TOWN OF MILFORD, NH  
OFFICE OF COMMUNITY DEVELOPMENT

## **STAFF MEMO**

**Date:** August 23, 2018  
**To:** Town of Milford Planning Board  
**From:** Lincoln Daley, Community Development Director  
**Subject:** **Hitchiner Manufacturing, Inc., 594 Elm Street, Tax Map 13, Lot 6 and 97 Old Wilton Road, Tax Map 14, Lot 6.** Public Hearing for an amendment to the major site plan approved on May 22, 2018, for the construction of an 85,000 square foot industrial manufacturing building and minor parking improvements to increase the total impervious area for a cooling tower concrete pad and associated drainage improvements within the Industrial zoning district.

Previously Approved 5/22/18  
4 Cooling Towers and drainage  
design.

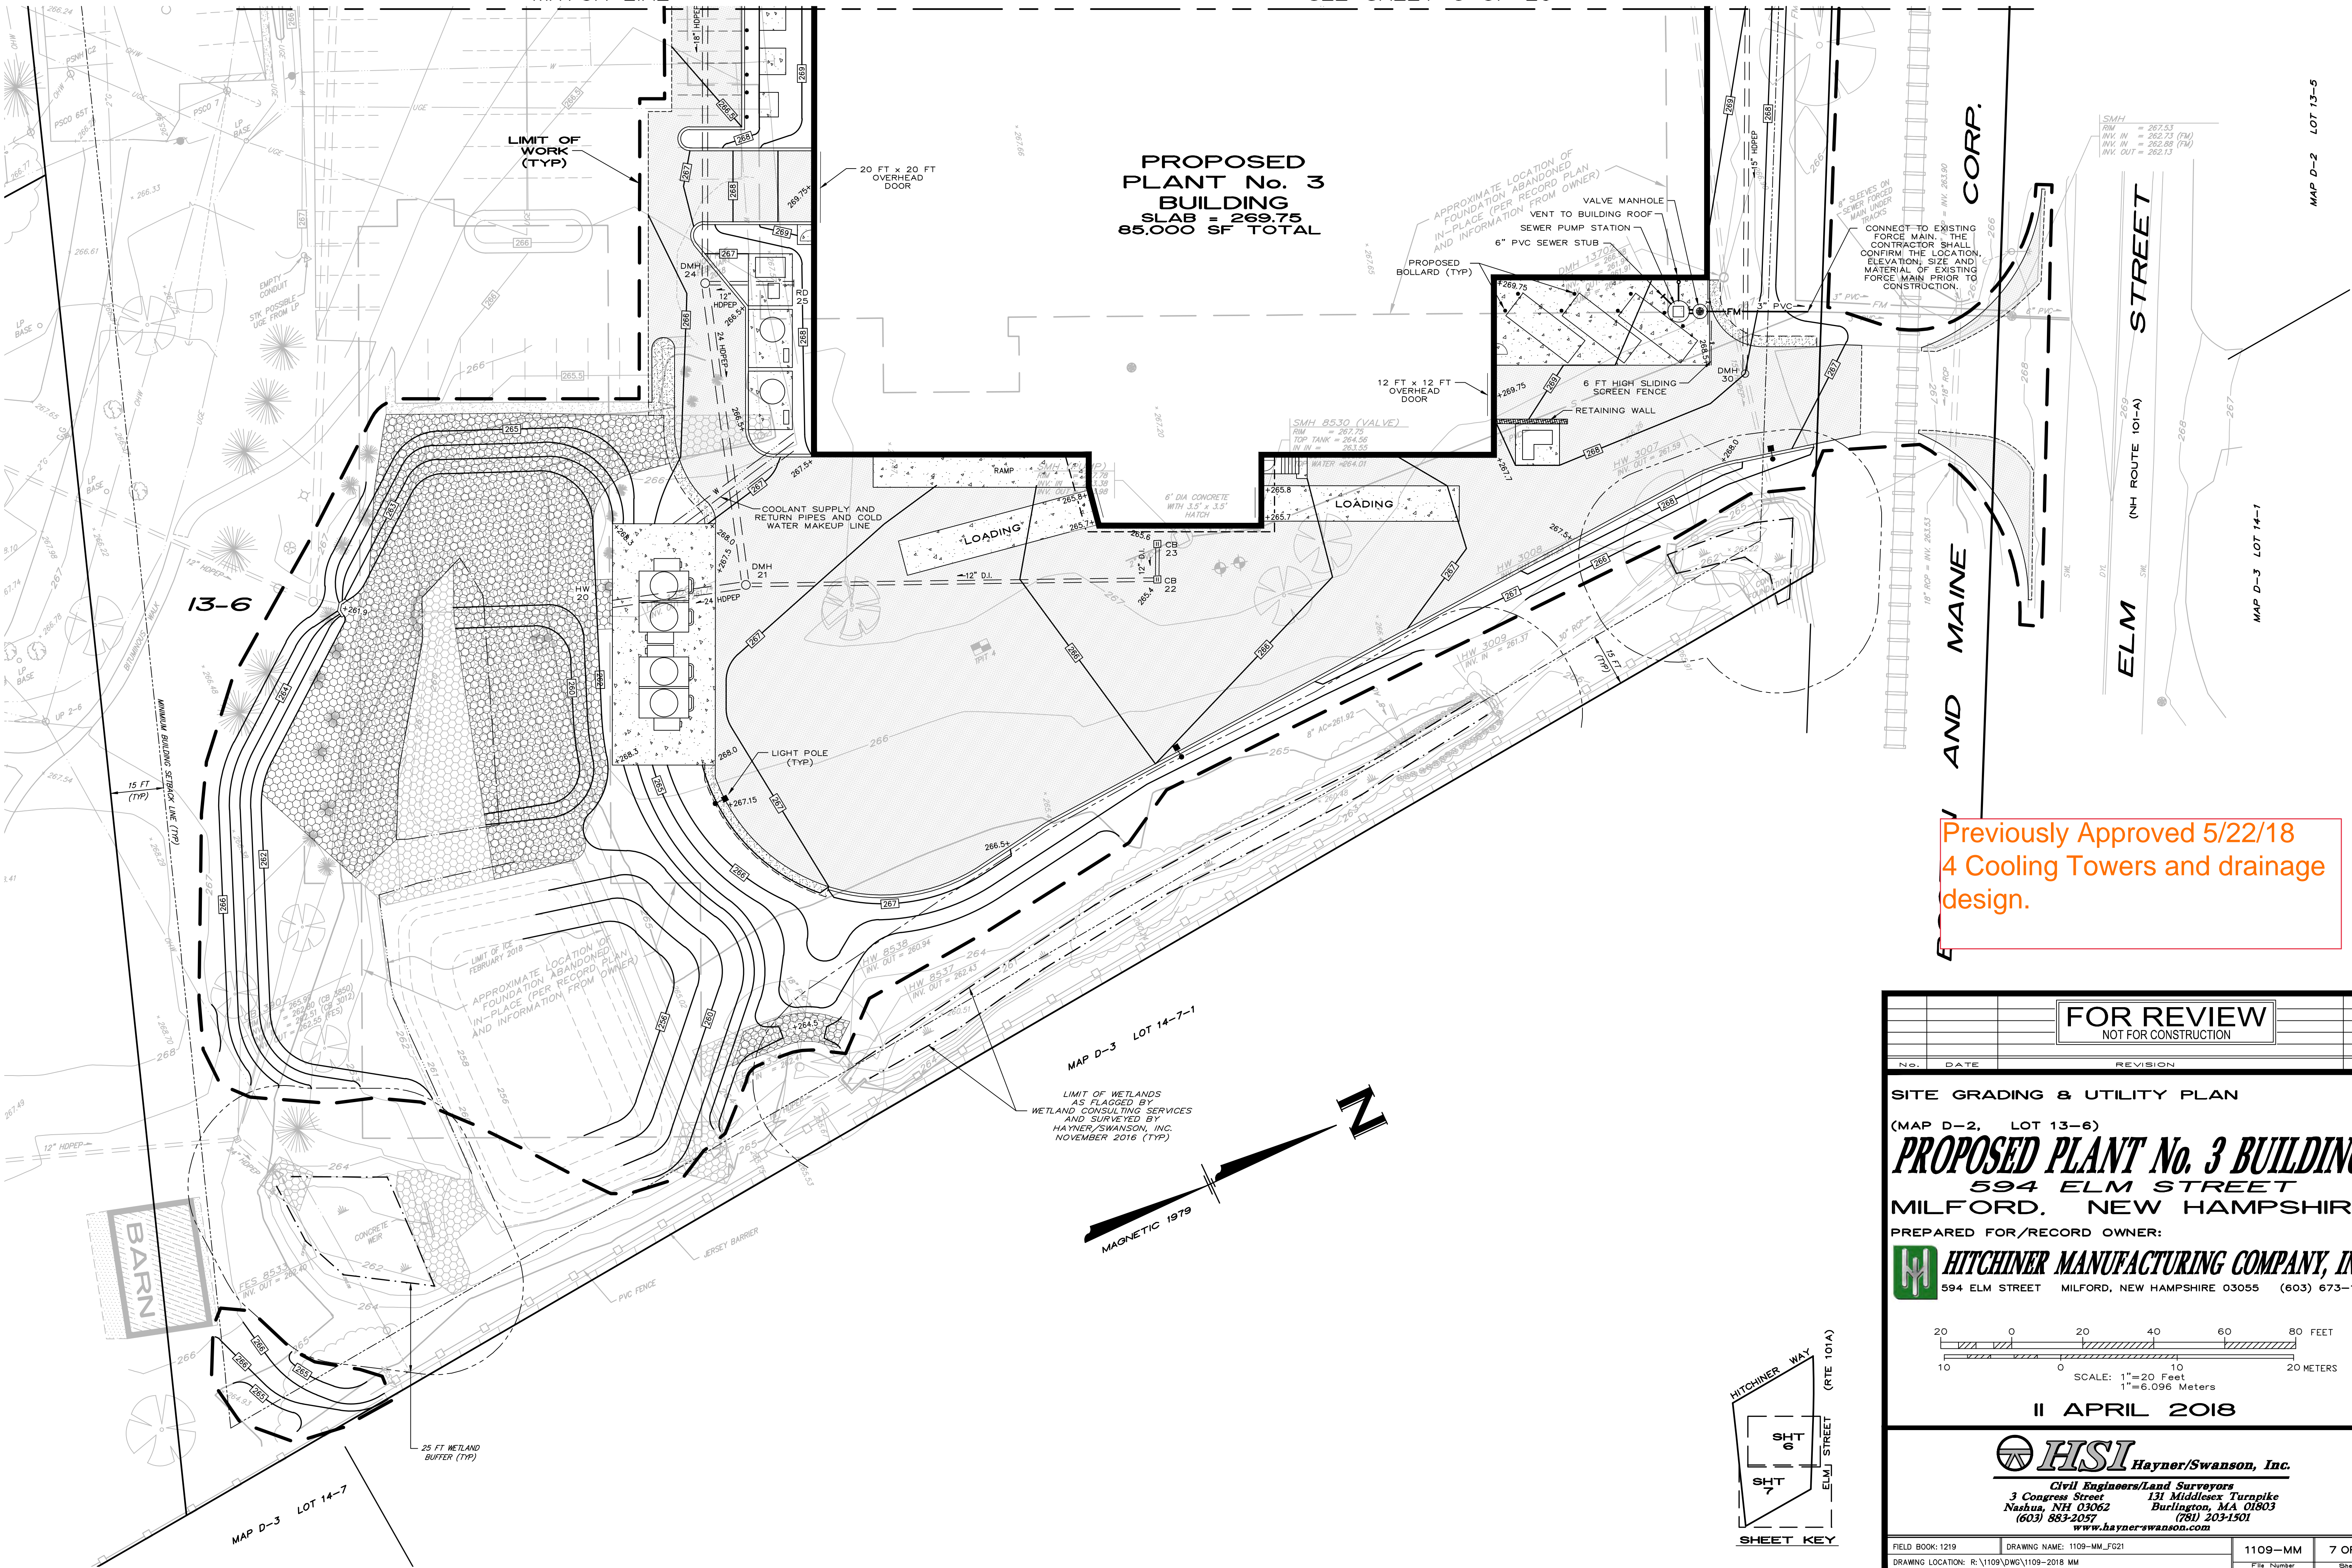
Since the approval, construction of the project is underway. Hitchiner has started foundation construction on the new Plant No. 3 building. They are seeking approval to (1) change from four evaporative cooling towers on a 29’x67’ concrete pad (previously approved) to seven adiabatic cooling towers on a 46’x110’ concrete pad (proposed revision) and (2) and adjustments to the drainage and stormwater management design and detention area resulting in a net increase of impervious area of 3,117 and 4,000 square feet to total disturbed area. This change will reduce water usage by approximately 1.5 million gallons annually.

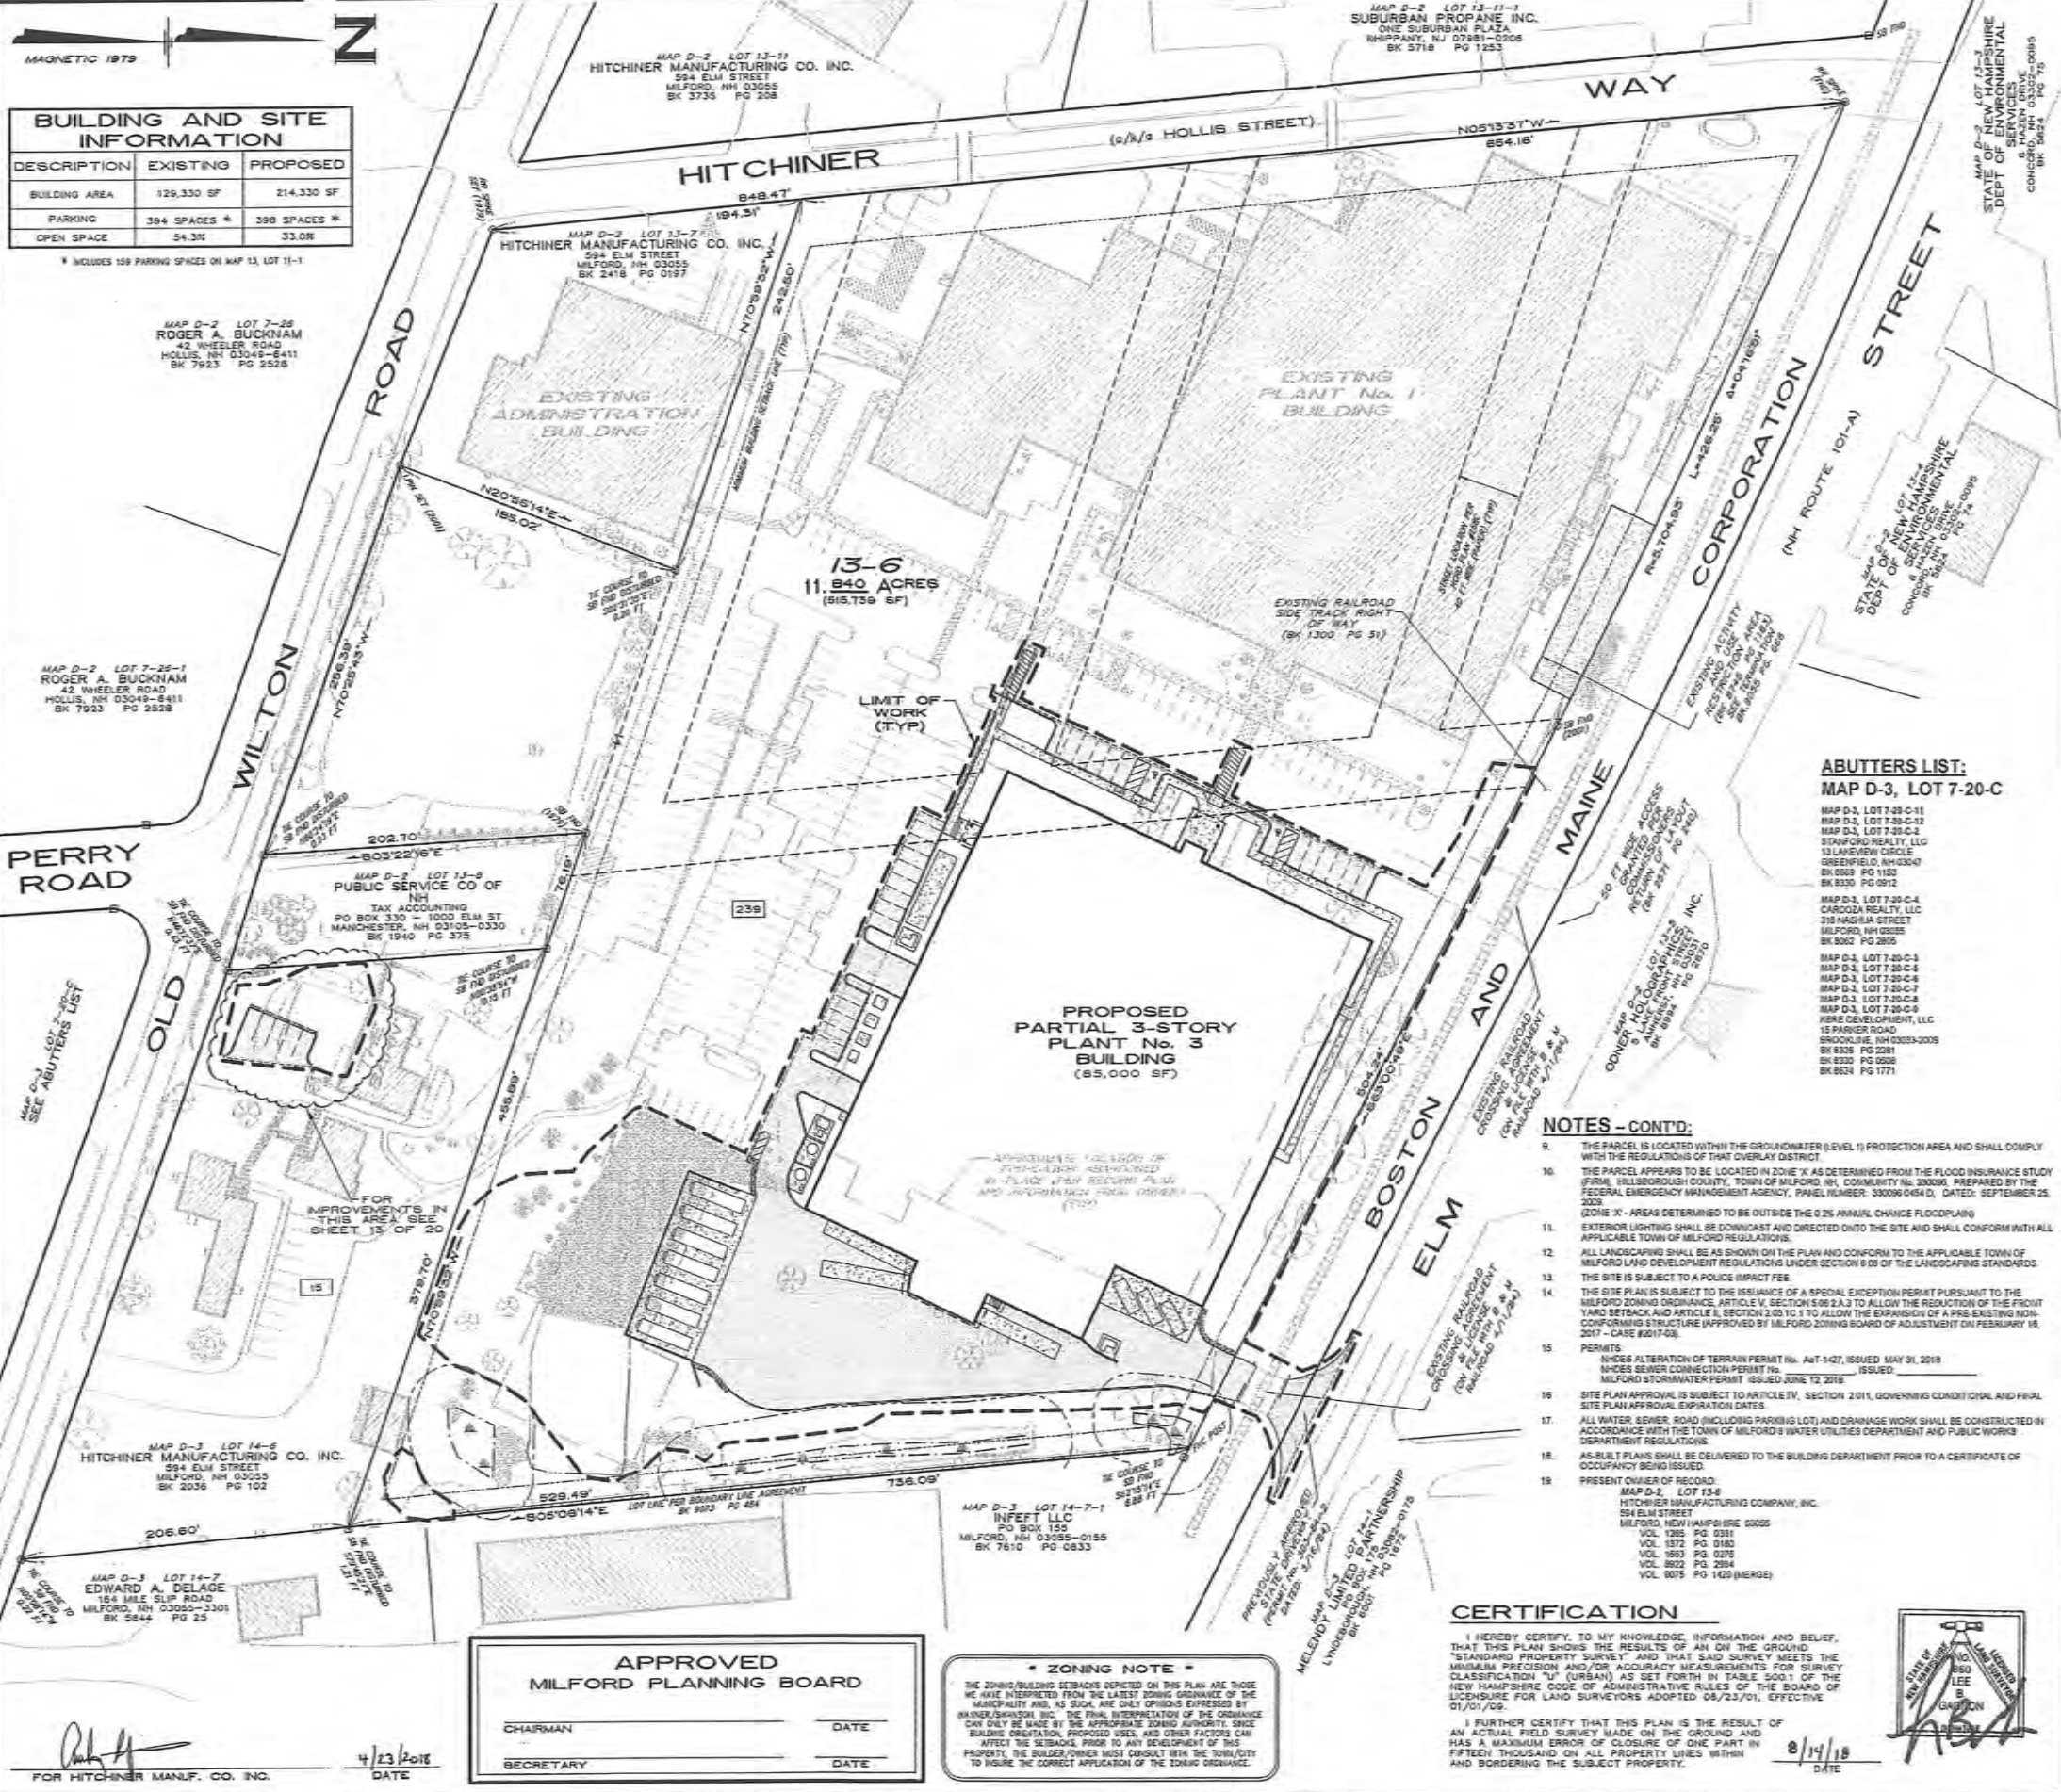
1. General Comment. Modify cover sheet to include both Map 13, Lot 6 and Map 16, Lot 6 in title and subsequent Sheet title blocks.
2. Sheet 1, Notes #4. Please amend the purpose of plan description to detail the proposed amendment(s).
